SITE PLAN REVIEW

LOT NO 34 REGISTERED PLAN

PROJECT/LOCATION RIVERWALK, PHASE 2 BRAMPTON, ON

DRAWING SITE PLAN

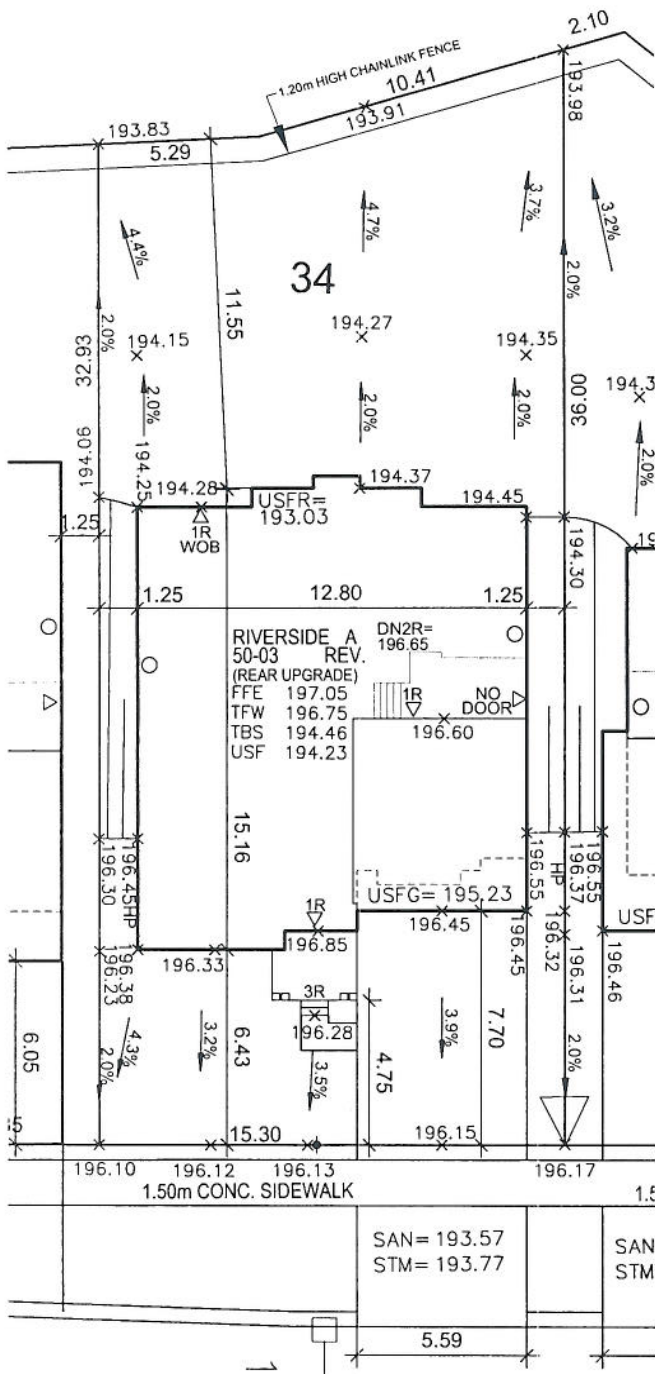
THE PROPOSED LOT GRADING AND DRAINAGE IS APPROVED AS BEING IN CONFORMITY WITH THE OVERALL APPROVED GRADING PLANS FOR THE SUBDIVISION.

NO COMMENT REVIEWED BY DATE April 5, 2016
